Access Compliance Report

Public Rights-of-Way

(Curb Ramps)

Intersection ID: 48422	Main Street: HAWICK_CT	Cross Street: EVANTON_LOCH_RD	Location: SE
ADA ID: D9BFCF624478	Ramp Type: PerpDiag	Initial Pass/Fail: Fail	Overall Compliance: No
Codes/Mitigation Info/Possible Solution		Field Measurements/Component Compliance	
Severity Score: 8.75

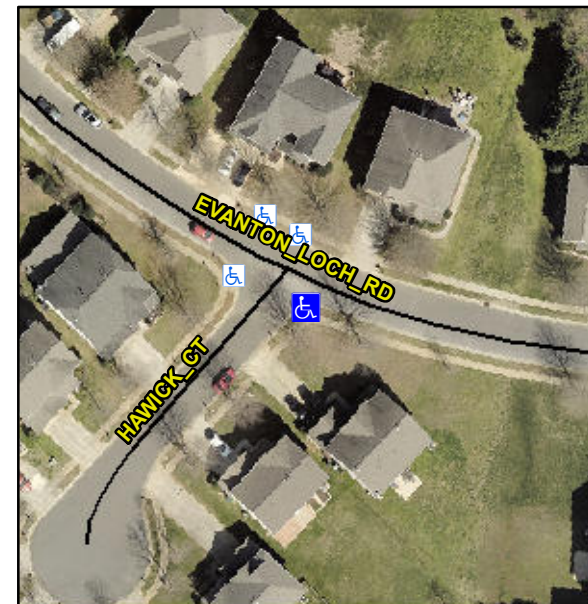
R304.5.1

Compliance	Description	Data	Compliance	Description	Data
N/A	Ramp Length (in)	48.0	Yes	Ramp Slope (%)	6.3
No	Ramp Width (in)	40.0	Yes	Ramp XSlope (%)	1.2
N/A	Flare Type LT	N/A	N/A	Flare Type RT	N/A
N/A	Flare Slope LT (%)	N/A	N/A	Flare Slope RT (%)	N/A
N/A	Flare Traversable LT?	N/A	N/A	Flare Traversable RT?	N/A
N/A	Landing Length (in)	N/A	N/A	DWS Provided?	N/A
N/A	Landing Width (in)	N/A	N/A	DWS Contrast?	N/A
N/A	Landing Slope (%)	N/A	N/A	DWS Length (in)	N/A
N/A	Landing X Slope (%)	N/A	N/A	DWS Full Width?	N/A
N/A	Landing Curb? (Y/N)	N/A	N/A	DWS Offset (in)	N/A
N/A	Shared Landing?	N/A			
N/A	Gutter Ponding?	N/A	N/A	Gutter Slope (%)	N/A
N/A	Gutter Lip Ht (in)	N/A	N/A	Gutter X Slope (%)	N/A
N/A	Painted X Walk1?	No	N/A	Painted X Walk2?	No
	X Walk 1 Direction	To NE		X Walk 2 Direction	To NW
N/A	X Walk 1 Width (in)	N/A	N/A	X Walk 2 Width (in)	N/A
	X Walk 1 Slope (%)	4.9		X Walk 2 Slope (%)	3.4
	X Walk 1 X Slope (%)	3.9		X Walk 2 X Slope (%)	1.8

Remove & Replace Curb Ramp With Two New Directional Ramps or Equivalent.
